STRATEGIC PLANNING COMMITTEE

ADDENDUM TO SERVICE DIRECTOR OF DEVELOPMENT MANAGEMENT AND BUILDING CONTROL'S REPORT

20/3742/FUL – Broadfields Estate, Bushfield Crescent, Edgware, HA8 8XH

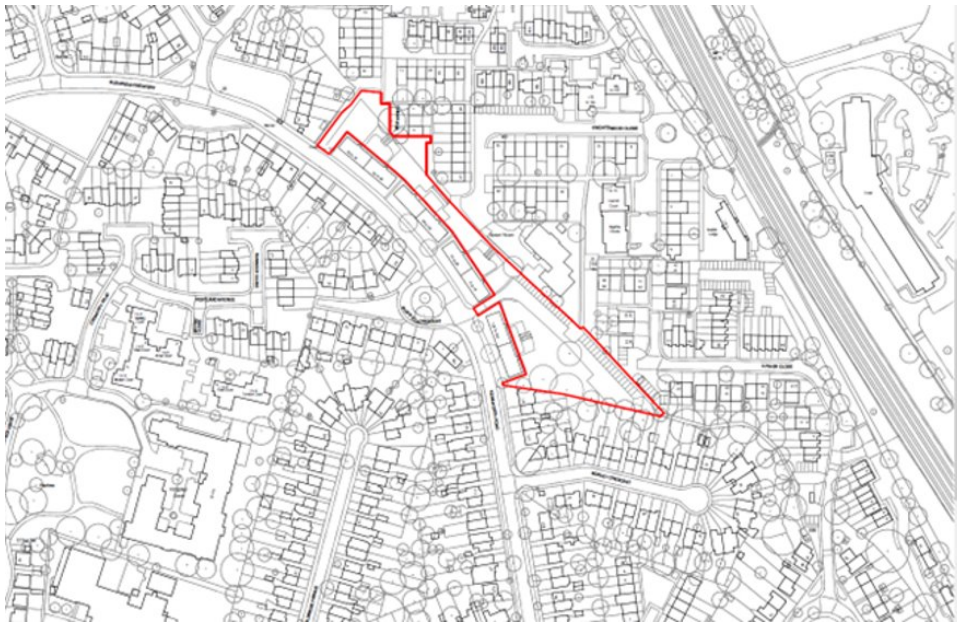
Incorrect site plan uploaded with report, site plan for the application is as below;
